<b>marantz®</b> <b>SERVICE BULLETIN</b>		Date: 15-May.-2003	Model: DV4300
		Page: 1 / 1	REF.NBR: MZ03-014
Circulation:		Subject:	
Application:		The unit doesn't work pushed ON/ OFF button of the remote controller RC3200.	
x for information customer complaint in case of service mandatory .....		Int.ref:	
See Below

<b>marantz®</b> <b>SERVICE BULLETIN</b>		Date: 25-Feb.-2004	Model: DV4300
		Page: 1 / 2	REF.NBR: MZ04-016
Circulation:		Subject:	
Application:		By crack of Laser Pickup slide shaft, Pickup stops moving and cannot playback the Disc.	
x for information customer complaint in case of service mandatory .....		Int.ref:	
See below

<b>marantz®</b> <b>SERVICE BULLETIN</b>		Date: 30-June-2003	Model: DV4300
		Page: 1 / 1	REF.NBR: MZ03-027
Circulation:		Subject:	
Application:		FFC and Top Cover short-circuit, and the unit can't be operated.	
x for information customer complaint in case of service mandatory .....	See Below	Int.ref:

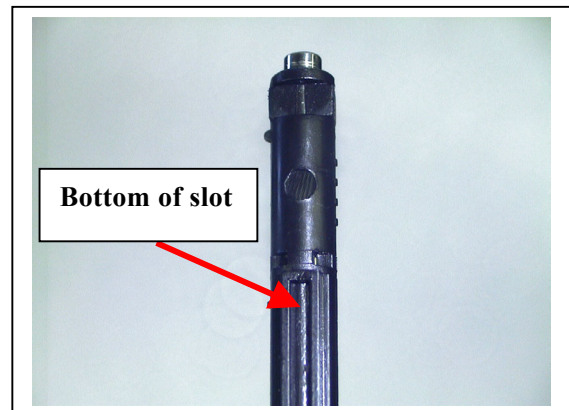
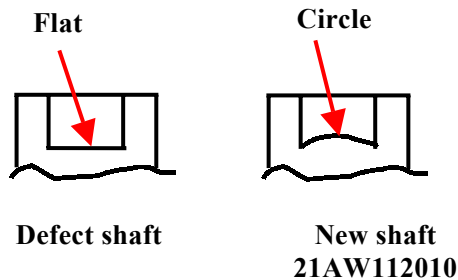
The part defect of the Laser Pickup slide shaft.  
(It occurs only in specific serial number because defective plastic part mixing.)

Difference of a shaft, the bottom form of slot is different.

- 1) **Replace the Laser Pickup slide shaft** of Loader Assy.
- 2) **Old Loader Assy Type no. RL-A700 corresponds.**
- 3) New Loader Assy Type no.DSL-710A does not correspond.

- 1) Part no. **21AW112010** (NEW Laser Pickup slide shaft)
- 2) Part no. **\*G75400000** (FLOIL G754 KANTO KASEI LTD.)

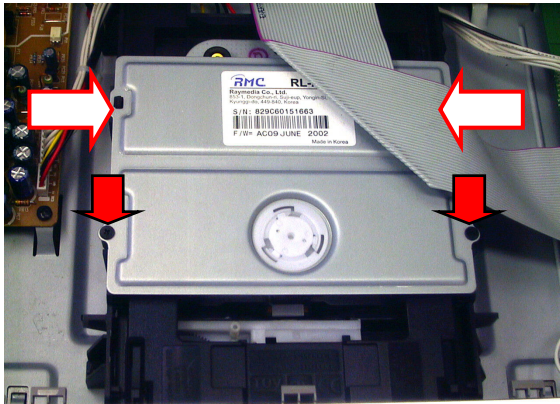
With the Unit which has returned from the customer by repair, the following serial number replace the Laser Pickup slide shaft.

This problem apply to following serial number  
 DV4300/U1B MZ000319028601 to MZ000319028650  
 DV4300/U1B MZ000326028811 to MZ000326029210  
 DV4300/N1G MZ010325029911 to MZ010325030610  
 DV4300/N1B MZ010325029211 to MZ010325029910  
 DV4300/N1B MZ010327033631 to MZ010327034130

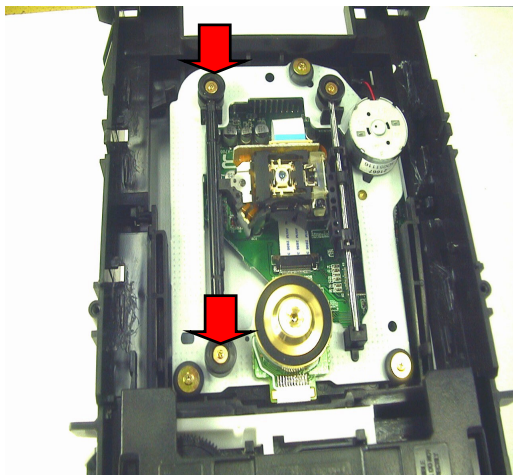
- 1. Open the disc tray.
- 2. Remove 2 screws.
- 3. Push 2 hooks to inside and remove the cover.

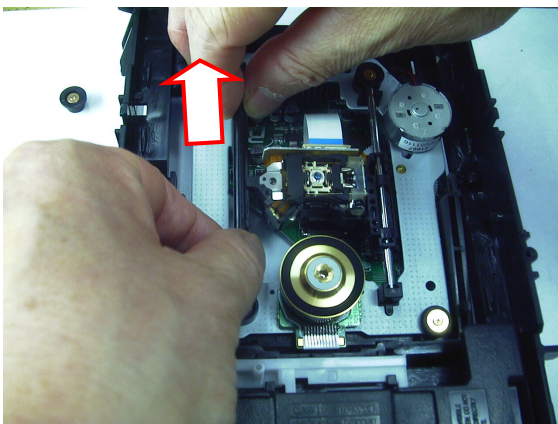
- 4. Remove 2 screws and remove plastic ring.

- 5. the Laser Pickup slide shaft is lifted to the upside and remove it

Range of apply grease.

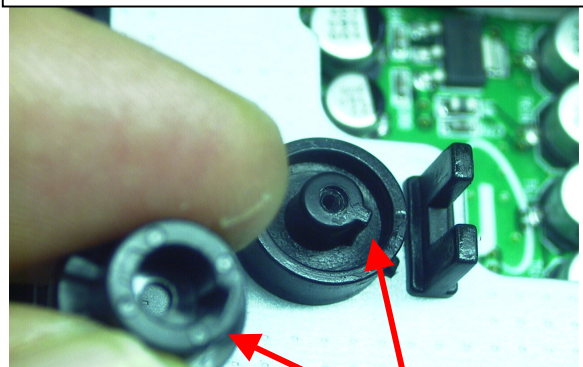
- 6. Grease is applied to the New Laser Pickup slide shaft

Grease (FLOIL G754) is applied to both sides of shaft.

When Pickup moves, grease is thinly applied so that it may not collect.

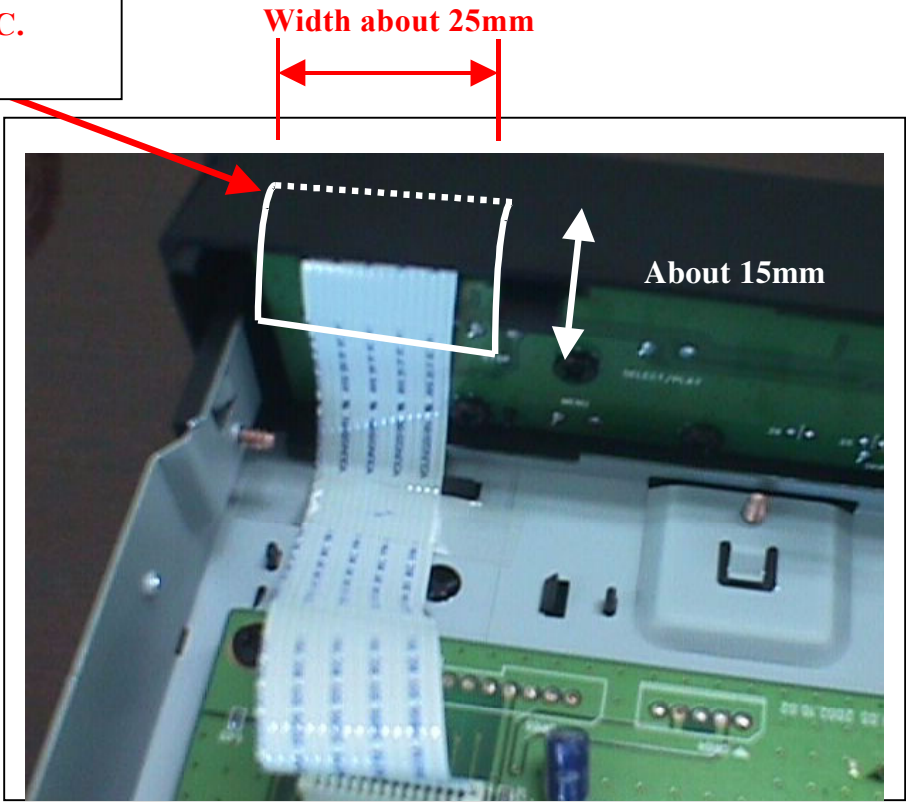
The insulation of Flexible Flat cable can be torn, and it short-circuits with Top cover, then can't be operated. Specially, the insulation of FFC which touches the tip of the Top Cover can be torn.

The insulator tape put on FFC.  
Especially, the place where the tip of the Top Cover touches FFC.  
The tape to use is **3M Scotch Filament Tape #895-2-206 or the equivalent.**

**You must put 3M Scotch tape in the point where the tip of the Top cover touches FFC.**
